# Summary of Comments on 2007-212-SUB2-PLANS\_review.pdf

**FOREST CREEK ESTATES LOT 4**  
SE1/4, NE1/4, SEC. 24, TWP. 24 N., RGE. 4 E., W.M.

**FOREST CREEK ESTATES LOT 4 PERMIT SET**  
5202 FOREST AVE S.E.  
MERCER ISLAND, WA 98040

**OVERLAY OF PLANS FOR REFERENCE.**

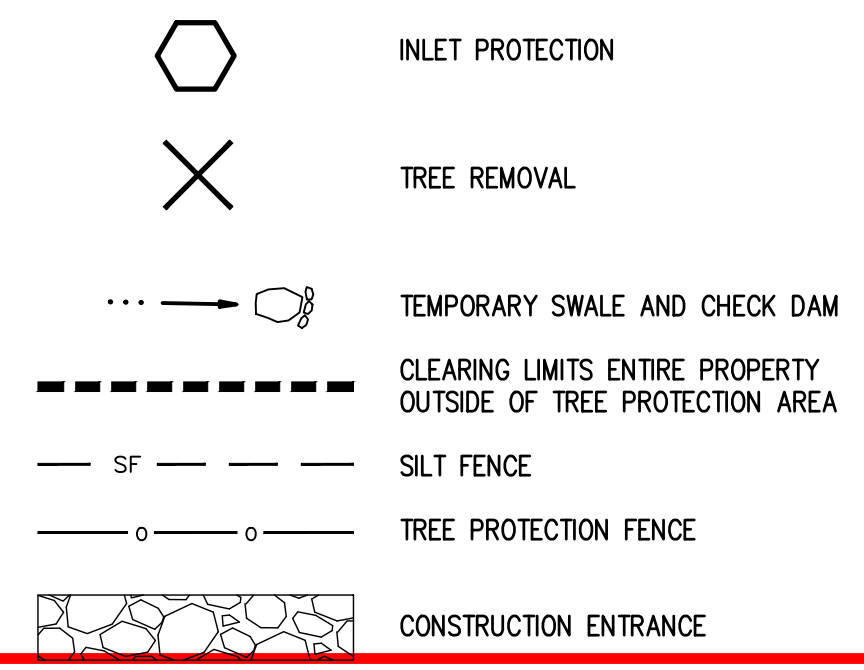
6. New comment because of change of plan sheet A1.2. Excavation limits have increased from sub-1. Adjacent properties Trees 301,302,319,321,320, 315 are now shown for removal in sub-2. Remove X though all trees that are not required to be removed for this retaining wall. All exceptional trees that have not been noted to be hazardous will need justification for removal per 19.10.060.A.2 (trees 302,315,319). Grading plan C1.0 does not show this over excavation shown on site plans and shows this minimized grading can work. Update A1.1 and A1.2 to reflect the grading plan. Only 2' of over excavation required over property line per grading plan.

Tree 315 shown on A1.2 only and not on C2.0. Also A1.2 includes removal of 314 (also not shown on C2.0).

Clearing limits now added to C1.0 and included with this submittal.

C2.0 TESC Plan shows limits of grading; all trees noted are required to be removed to construct the retaining wall.

Noted - Arch to address.
